## Council Sub-Committee on Transportation at Obey Creek

*Sub-Committee Meeting – February 26, 2015 from 4:00-6:00pm  
in the Planning conference room (third floor) of Town Hall*

**Date:** January 06, 2015  
**To:** David Bonk, Kumar Neppalli, PE  
Town of Chapel Hill, North Carolina  
**From:** Bill Schultheiss, PE  
**Re:** South Columbia Street and Otey's Road Safety Review and Concept Development

Obey Creek –  
Detailed Transit Analysis Update

SHEET NAME:  
 Oteys Road  
 Proposed Condition  
 DRAWING NUMBER  
**SK-11**  
 SHEET NUMBER  
**11** OF **13**

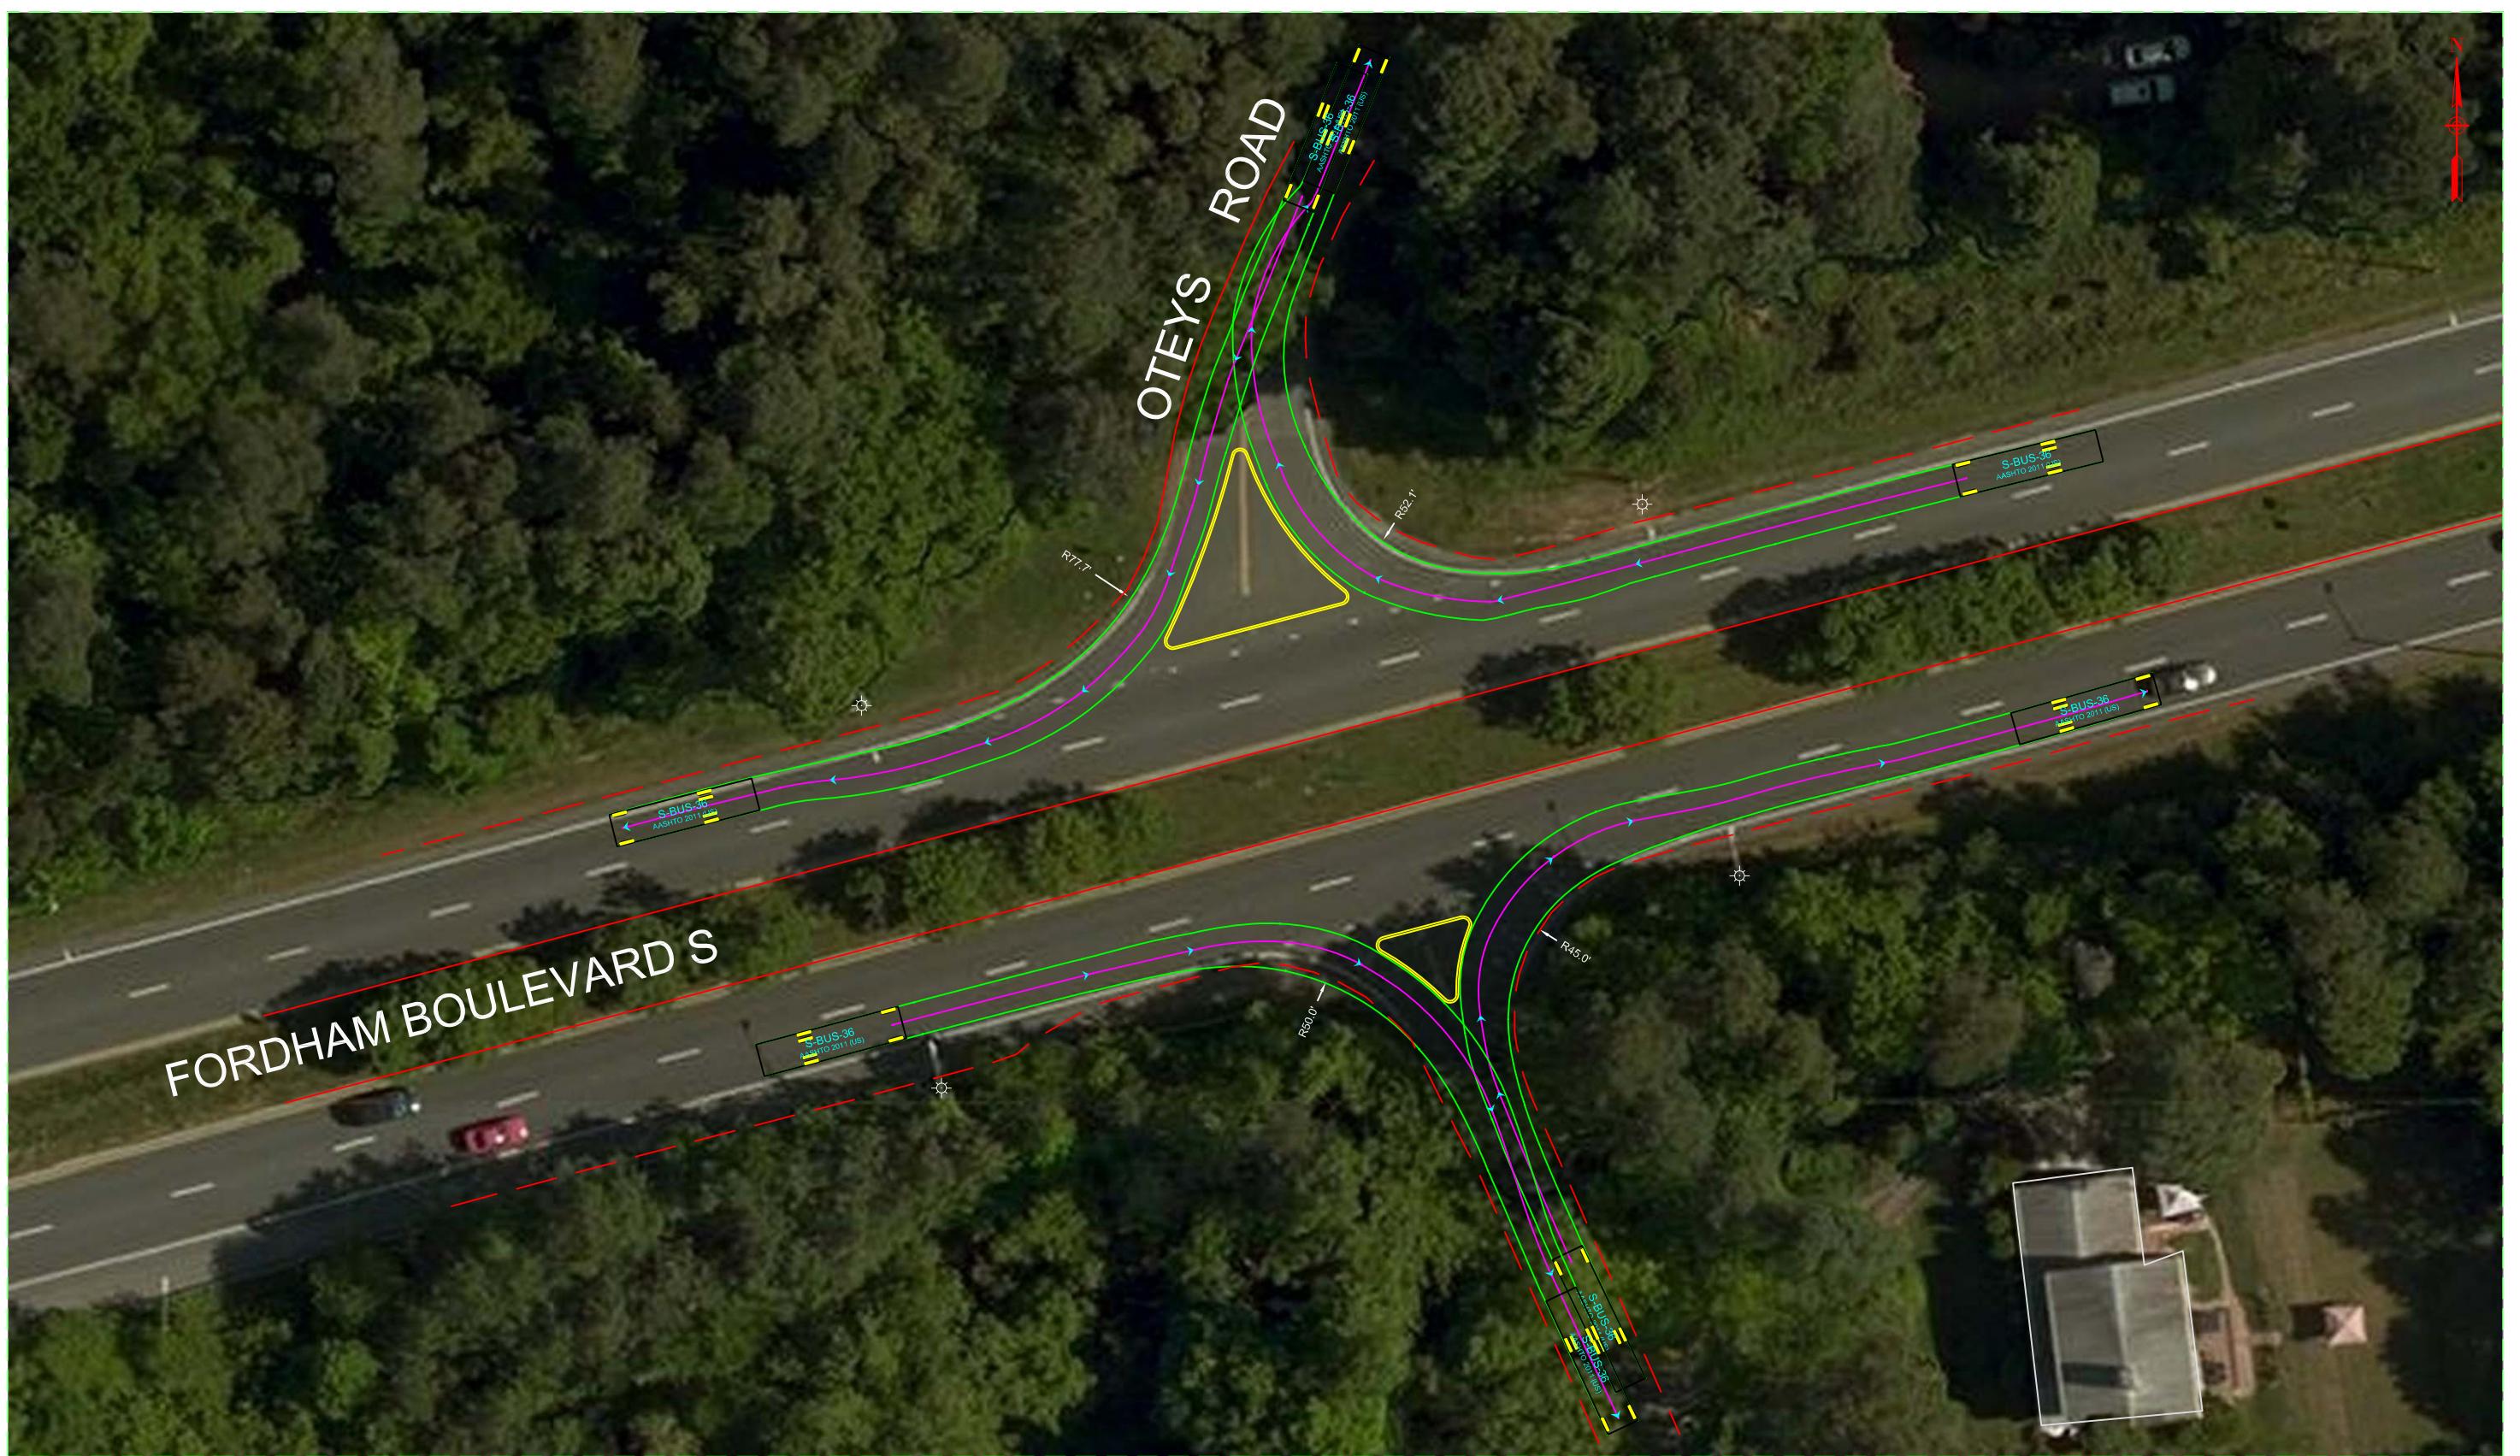
The Town and UNC bicycle plans recommended development of a pedestrian and bicyclist crossing of Fordham Boulevard. Provision of a safe crossing at this location would create an additional crossing between South Columbia Street and Manning Drive for non-motorized travel. Fordham Boulevard acts as a significant barrier to non-motorized travel as Manning Drive and South Columbia streets are separated by more than one mile. To safely cross Fordham Boulevard it will be necessary to modify the median to provide refuge, channelize traffic turning onto and off from Fordham Boulevard, and to install a traffic signal to stop traffic on Fordham Boulevard. The traffic signal can potentially be Pedestrian Hybrid Beacon or a full traffic signal. Given the lower volume of pedestrian and bicycle traffic likely this location it is recommended a relatively short response be provided to reduce the likelihood of users crossing against the light as gaps in traffic appear. The maximum wait time is suggested at 30 seconds. If this is not achievable, it is advisable the signal at least be coordinated with the signal at Manning Drive.

- Crossing island improvements for bicyclist and pedestrians within the median
- Sidewalk improvements
- Proposed location for channelizing islands on Otey's Road
- Proposed HAWK signal on Fordham Boulevard
